DRAWINGS AND DESCRIPTION OF PROPOSED CHANGES

TOTTENHAM HALE CENTRE
ISLAND SITES
PROPOSED L07 FLOOR PLAN

3.4 BUILDING 1 UPPER FLOORS - SEVENTH FLOOR

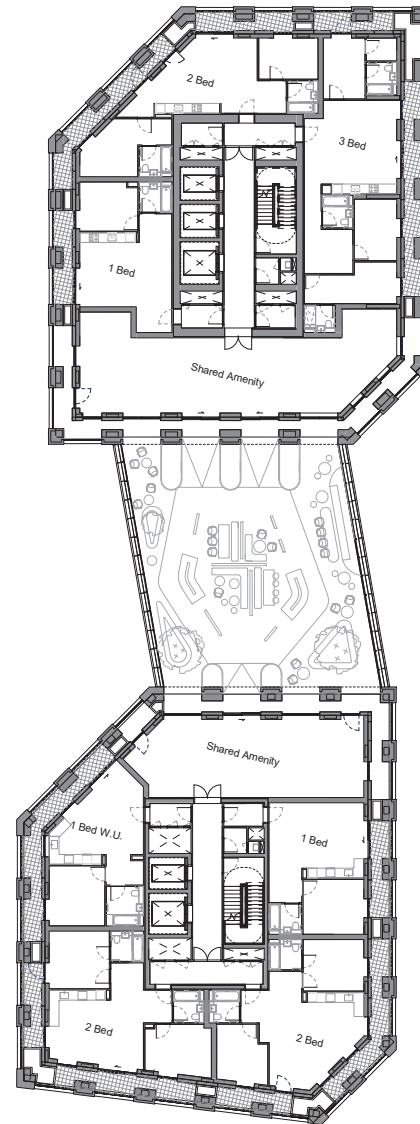
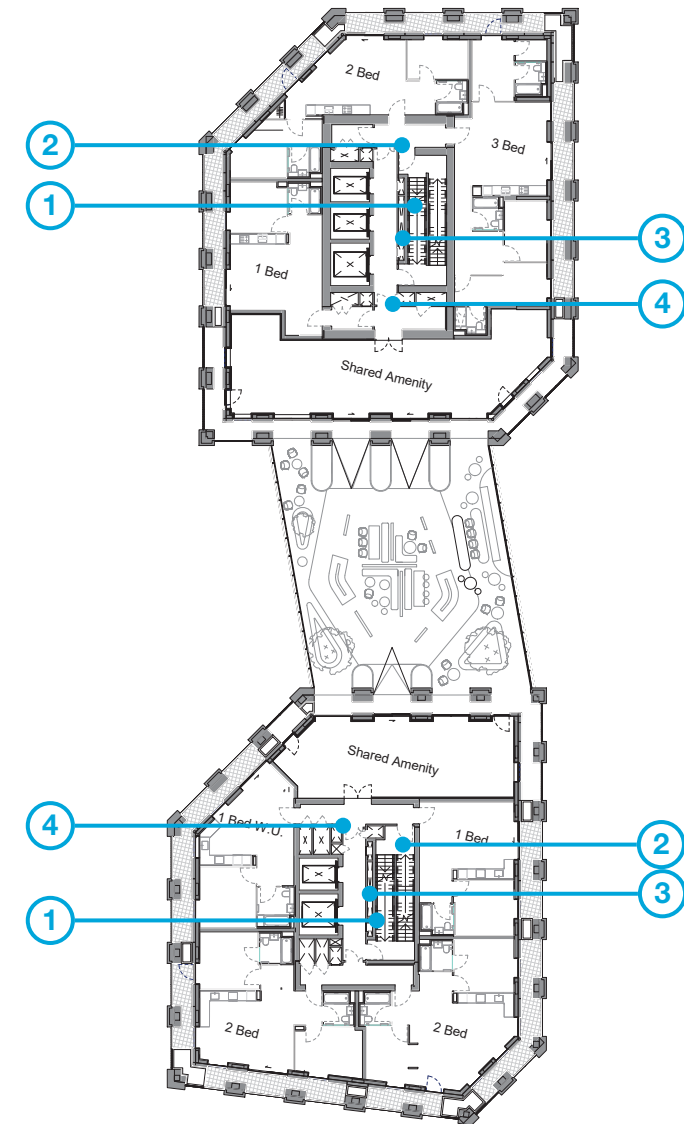
1. A second fire escape stair has been added between ground floor to upper levels.
2. Due to the addition of the second stair, the position of the access to the stairs has changed to resolve level changes across all floors.
3. Service risers have been relocated within the core following the addition of the second staircase.
4. Additional doors have been added within the communal corridors to comply with the latest fire strategy.
